Subject: Project No. 704 – BWRVIP Response to NRC Request for Additional Information on BWRVIP-234

Request for Additional Information on BWRVIP-234: Thermal Aging and Neutron Embrittlement Evaluation of Cast Austenitic Stainless Steel for BWR Internals

Each item from the NRC Request for Additional Information (RAI) is repeated below verbatim followed by the BWRVIP response to that item.

Figure 1. Decrease in Charpy-impact energy for various heats of cast stainless steels aged at 400°C

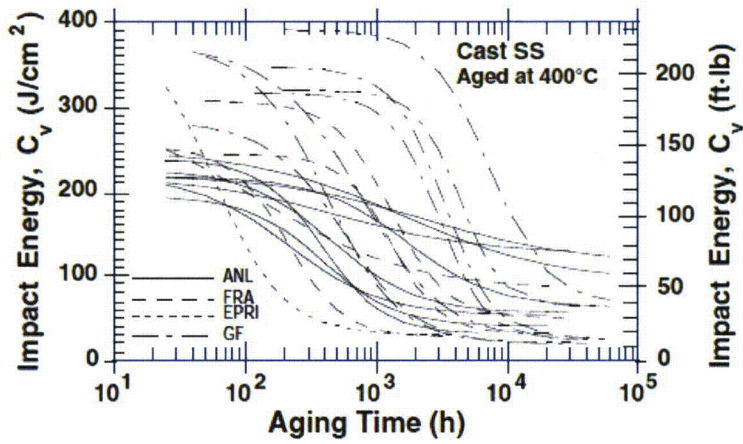
For Figure 2-1, the absorbed energy saturation values for the CF-8M castings are between 10 and 20 ft-lbs. The saturation is reached in about 10^5 hours at a temperature of 300°C. These values are independent of the delta ferrite content. Is this result consistent with other alloys like CF-8 and CF-3?

The purpose of Figure 2-1 was to show that CF-8M is very susceptible to thermal embrittlement (TE). In fact it is the least resistant of the CASS materials to TE. This is consistent with results reported in NUREG/CR-4513, Revision 1 (Reference 13 in BWRVIP-234) and Reference 5 of BWRVIP-234.

NUREG/CR-4513, Revision 1, Section 3.2.1, states that the saturation room temperature (RT) impact energy of a specific cast stainless steel is indeed a function of the chemical composition and the ferrite content of the material. Page 3 of NUREG/CR-4513, Revision 1 states the following:

“The decrease in RT Charpy–impact energy during thermal aging at 400°C (752°F) of various heats of cast stainless steel^{4-6,15,19,21} is shown in Fig. 1. The results indicate that all the materials reach a “saturation” RT impact energy, i.e., a minimum value that would be achieved by the material after long–term aging. The actual value of saturation RT impact energy for a specific cast stainless steel is independent of aging temperature but depends strongly on the chemical composition of the steel; it is lower for the Mo–bearing CF–8M steels than for the Mo–free CF–3 or CF–8 steels, and decreases with an increase in ferrite content or the concentration of C or N in the steel.”

The saturation values of Charpy–impact energy for CF-3 and CF-8 materials used in BWRs are above CF-8M castings. Furthermore, Reference 5 of BWRVIP-234 states that “CF8M shows the greatest susceptibility to thermal aging of any of the other SA-351 grades considered in the screening criteria.”
